How to change Mini Card (Half Size) & Cfast to mSATA on GENE-BT05

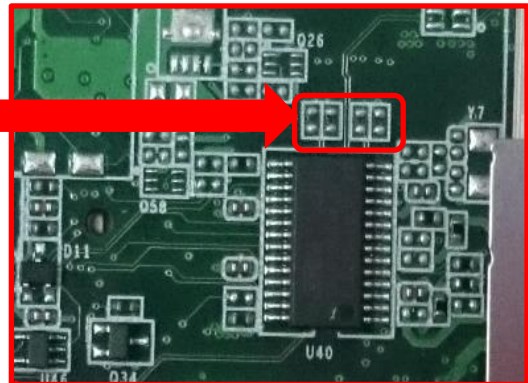
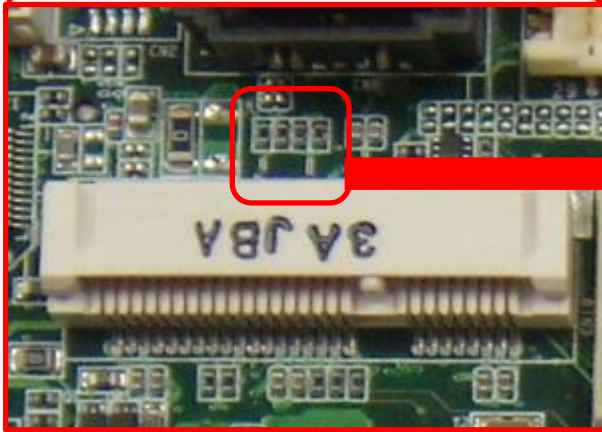
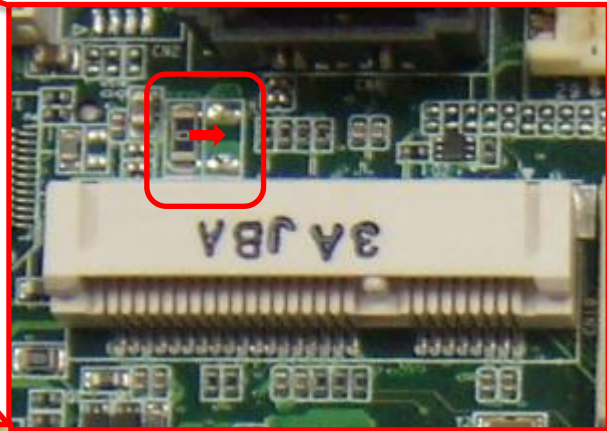
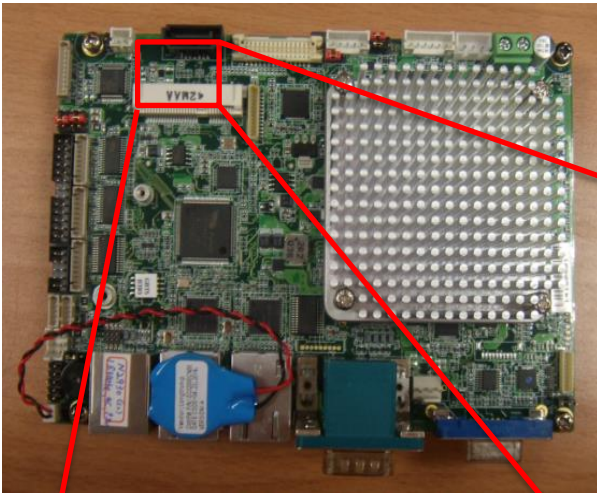
1. Move the 1206 resistor (P/N:1050700002) right by original location. Move R38 to R11.

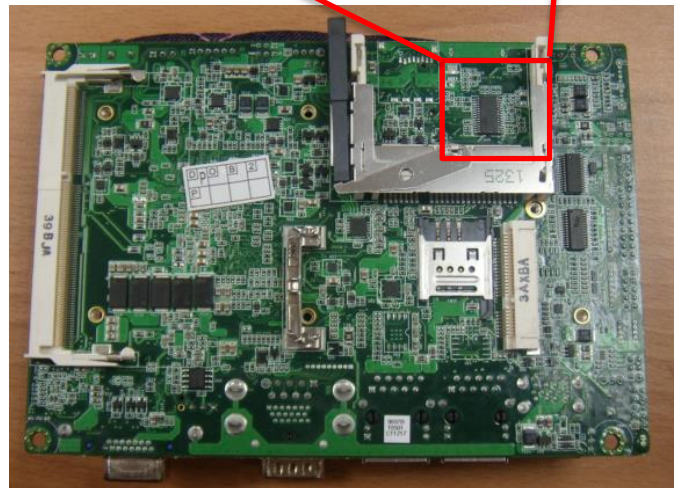
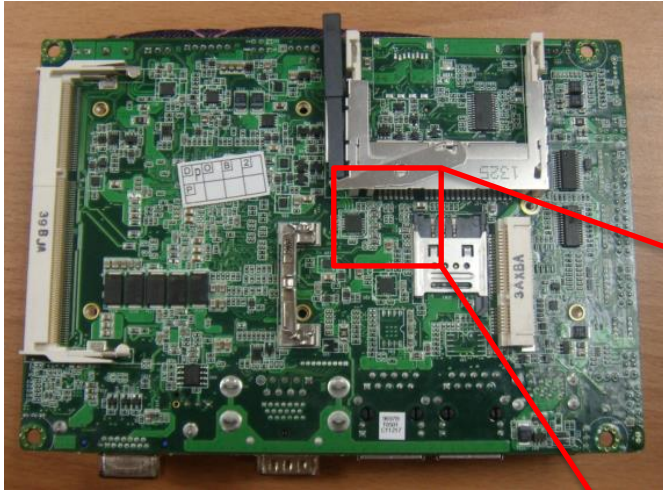
2. Move the 0402 resistors (P/N:105A700009) to Solder side.

- (a) Move R39 to R394.
- (b) Move R40 to R393.
- (c) Move R41 to R396.
- (d) Move R42 to R395.

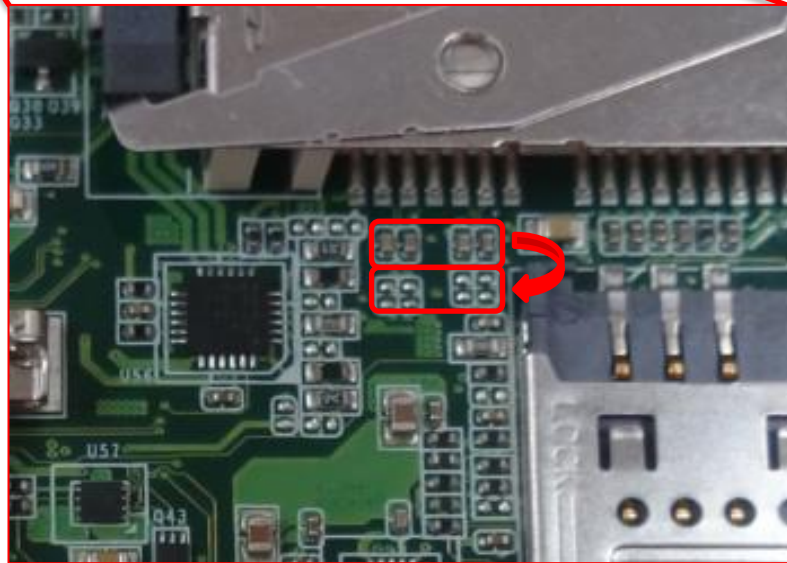
3. Move the 0402 capacitors.
(P/N:1129701791)
- (a) Move C394 to C495.
 - (b) Move C393 to C496.
 - (c) Move C392 to C500.
 - (d) Move C391 to C499.

4. Remove CFast Header and Push Ejector(CN33)
(P/N:1653924110&165390003B)
